Technical Service Bulletin

20-ST-001H-1

SUBJECT: COLUMN-MOUNTED MDPS REPAIR INFORMATION

THIS TSB SUPERSEDES 20-ST-001H TO INCLUDE ADDITIONAL C-MDPS COMPONENTS, DIAGNOSTIC, AND REPAIR INFORMATION.

Torque Angle Sensor (TAS) Wiring Inspection

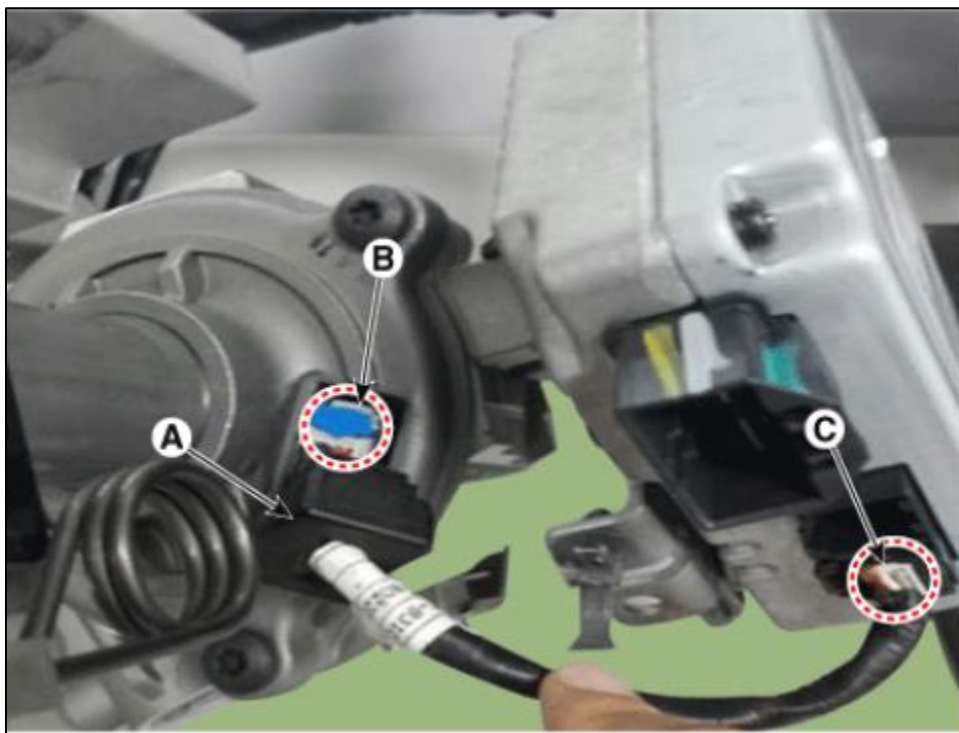
In the presence of DTC C1259 (steering angle sensor signal error) and/or C1290 (torque sensor signal error), inspect the condition of the TAS wiring.

Remove the grommet (A) and check the wiring on both TAS side (B) and ECU side (C). Check for damage, push-back, or improper connection.

If any issues are found in this harness, replace the full C-MDPS (part number starting with 56310) assembly.

C-MDPS mounting

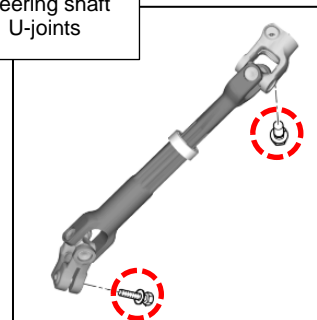
2. Check C-MDPS mounting area
 - Check cowl mounting bolts (check below C-MDPS mounting bolts)
 - Check cowl cross member mounting bolts.
 - *Tighten bolts to the specified torque in the shop manual.*

Steering shaft U-joints

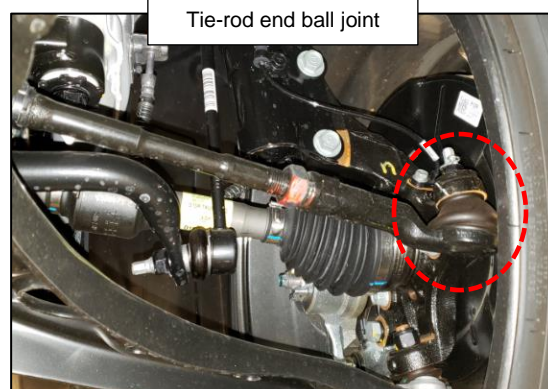
3. Check steering intermediate shaft U-joint bolts.
 - Remove and check U-joint assembly for noise.
 - *Replace shaft or tighten bolts to the specified torque in the shop manual.*
 - **NOTICE: If the pinch bolts on either ends of the steering universal joint assembly are removed, the bolts cannot be reused during reassembly.**

Method #1

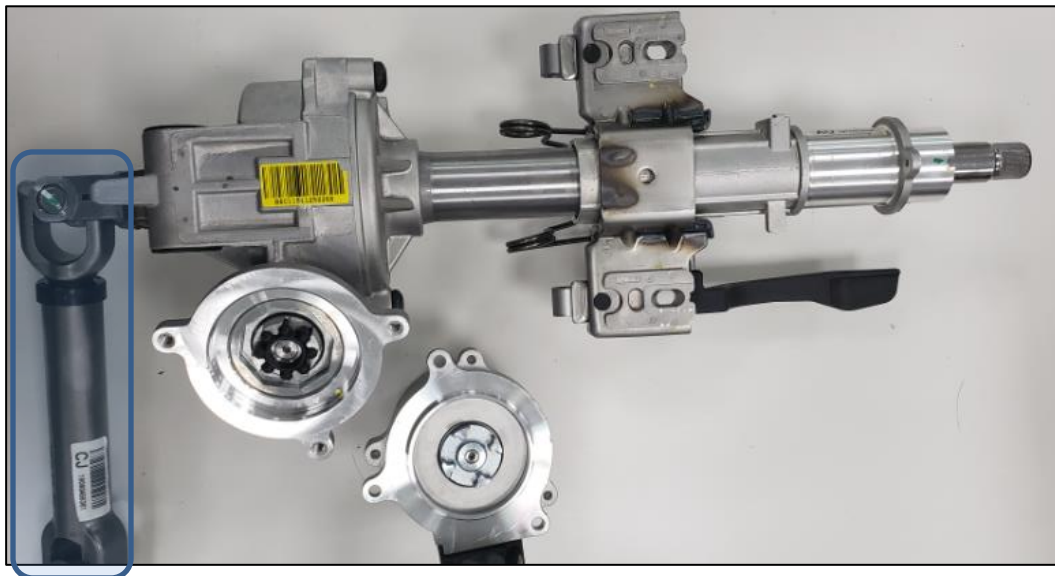
- Use Chassis Ears (SST #J-39570) attached to the areas shown below to isolate source of noise within C-MDPS assembly.
- One way to verify that the source of noise is the column & housing assembly is to remove the part, and turn the assembly with the C-MDPS motor removed, as shown below.

Use intermediate shaft to turn steering column.
